Access Compliance Report

Public Rights-of-Way

(Curb Ramps)

Intersection ID: 14840	Main Street: N_LAUREL_AV	Cross Street: VAIL_AV	Location: NE
ADA ID: 6AA2A4C6CEF1	Ramp Type: ParaDiag	Initial Pass/Fail: Fail	Overall Compliance: No
			Severity Score: 13.75

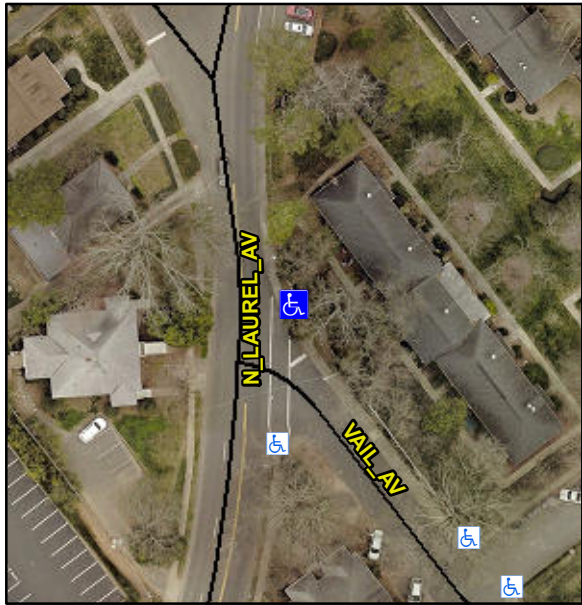
Codes/Mitigation Info/Possible Solution			Field Measurements/Component Compliance					
	Possible Solutions:		Compliance	Description	Data	Compliance	Description	Data
	Remove & Replace Curb Ramp With Two New Directional Ramps or Equivalent.		N/A	Ramp Length LT (in)	68.0	N/A	Ramp Length RT (in)	72.0
			Yes	Ramp Width LT (in)	55.0	Yes	Ramp Width RT (in)	54.0
			Yes	Ramp Slope LT (%)	2.9	No	Ramp Slope RT (%)	9.5
			Yes	Ramp XSlope LT (%)	0.0	No	Ramp XSlope RT (%)	2.3
			N/A	Landing Length (in)	N/A	N/A	DWS Provided?	N/A
			N/A	Landing Width (in)	N/A	N/A	DWS Contrast?	N/A
			N/A	Landing Slope (%)	N/A	N/A	DWS Length (in)	N/A
			N/A	Landing X Slope (%)	N/A	N/A	DWS Full Width?	N/A
			N/A	Landing Curb? (Y/N)	N/A	N/A	DWS Offset (in)	N/A
Surveyor Notes:			N/A	Shared Landing?	N/A			
LT RP < 5%			N/A	Gutter Ponding?	N/A	N/A	Gutter Slope (%)	N/A
PROW/ADA:			N/A	Gutter Lip Ht (in)	N/A	N/A	Gutter X Slope (%)	N/A
R304.3.2, R304.5.3			N/A	Painted X Walk1?	No	N/A	Painted X Walk2?	Yes

X Walk 1 Direction	To W		X Walk 2 Direction	To S
			N/A	X Walk 1 Width (in)	N/A	N/A	X Walk 2 Width (in)	125.0
				X Walk 1 Slope (%)	5.5		X Walk 2 Slope (%)	7.6
				X Walk 1 X Slope (%)	5.3		X Walk 2 X Slope (%)	2.1
			N/A	Ramp inside XWalk1?	N/A	N/A	Ramp inside XWalk2?	Yes
				Road Slope (%)	1.1	N/A	Clear Space?	N/A
				Road X Slope (%)	7.4	N/A	Clear Space to XWalk (in)	N/A
			N/A	Any Obstructions?	N/A	N/A	Storm Grate/Utility Hazard?	N/A
				Obstruction Type			Storm Grate/Utility Type	
Total Cost:		\$ 3200.00			N/A			N/A
						Yes	Surface Condition? (G/P)	Good
						N/A	Curb Slope (%)	4.9
